Construction Division
Additions & Alteration Charges Approval Form

GULMOHAR RESIDENCY

Details of Additions & Alterations

Flat No		Block no.	'H'
Flat Area	406	Type	Deluxe / Luxury
Buyer Name	1360 sq ft		
Phone No.	Mr. Jahnabi Nayak	Email

Changes in kitchen platform: (mark on plan)

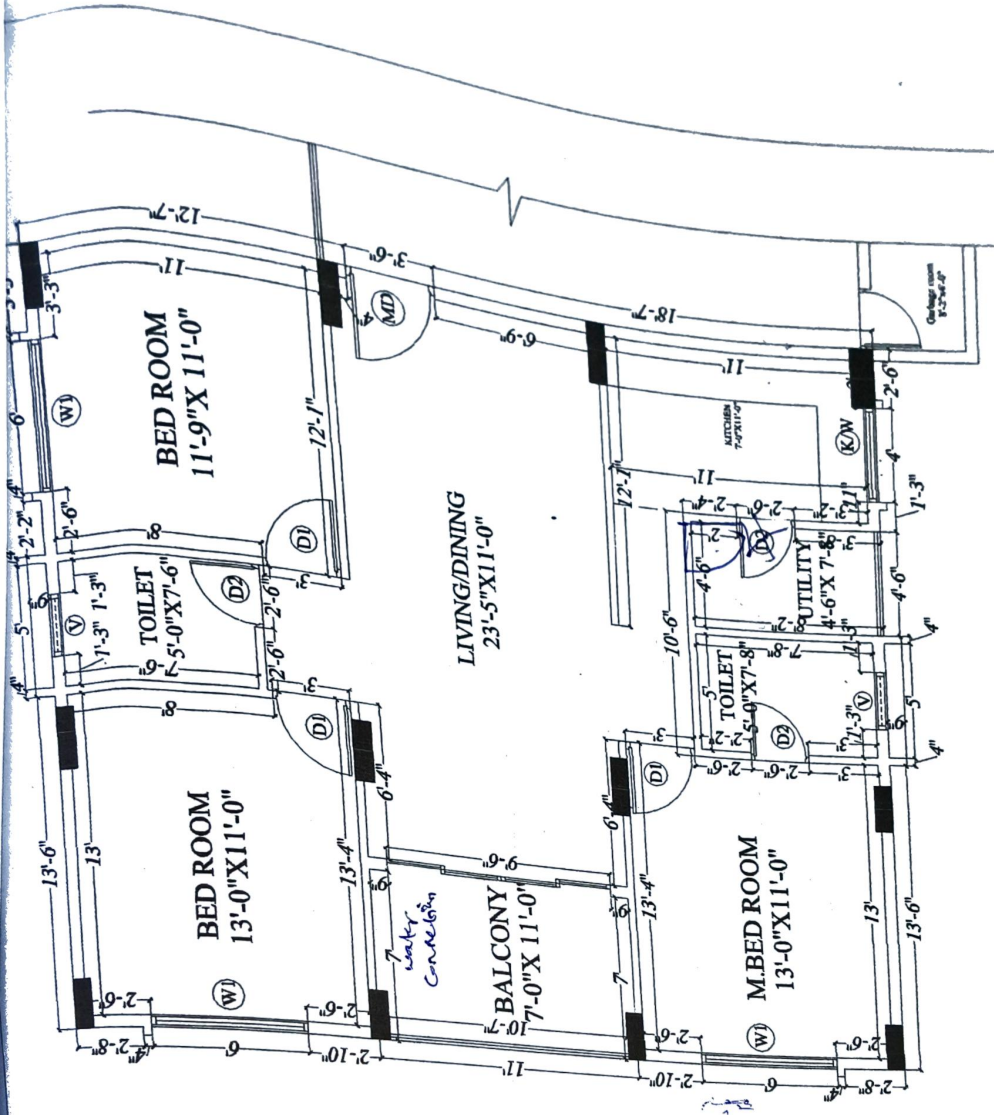
④ SS Sink by Custom - Lali.

ELECTRICAL PLAN -1360 sqt FLATS-A1 TYPE

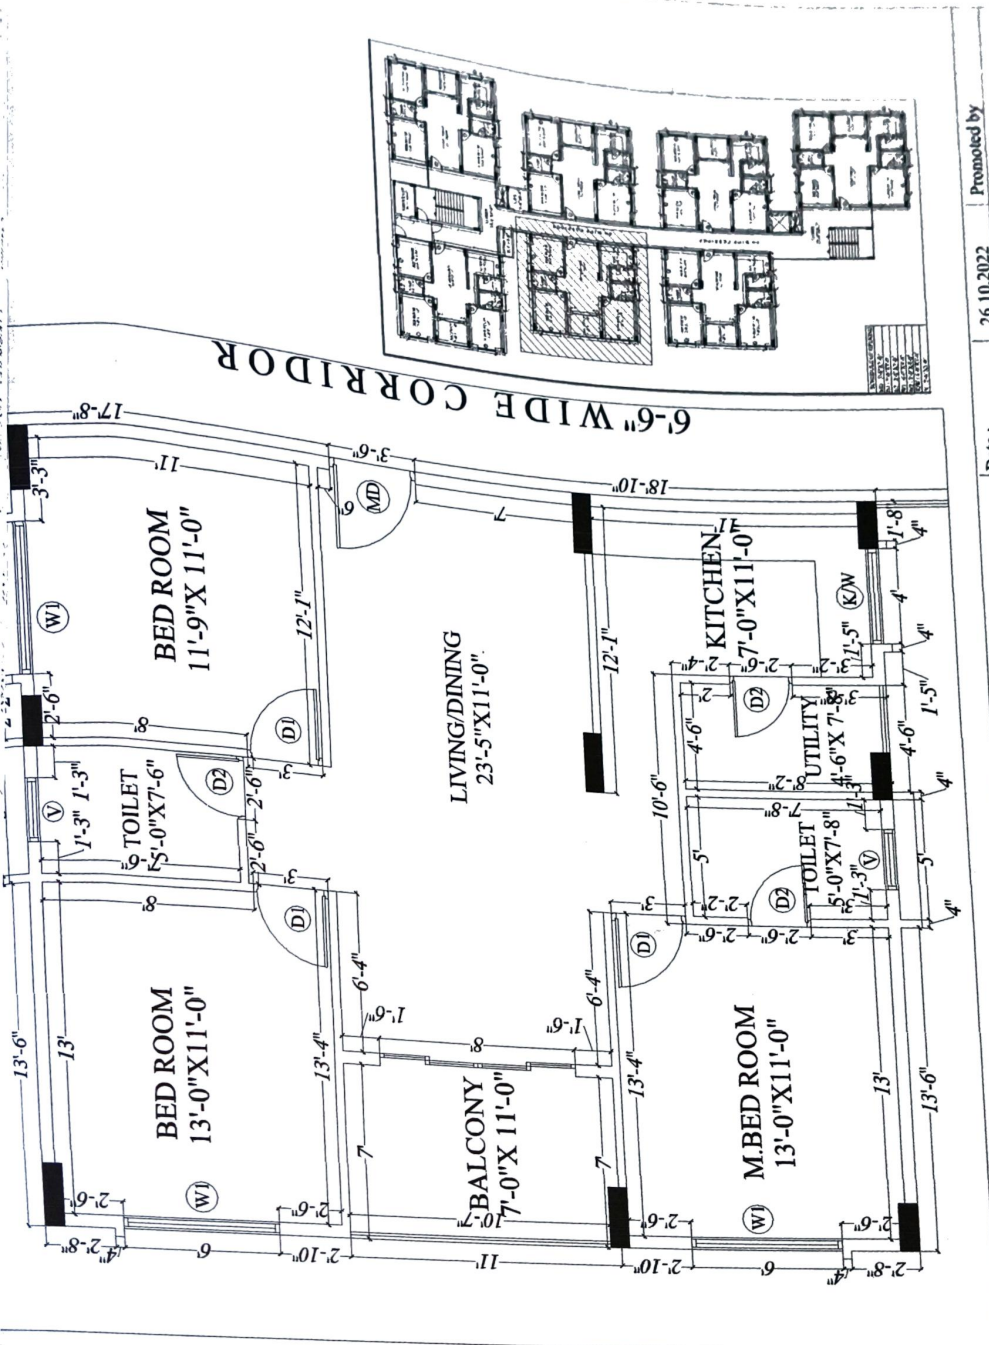
- * Two way points in all 3 bedrooms.
- * Both side of beds 6M box is required in all 3 rooms.
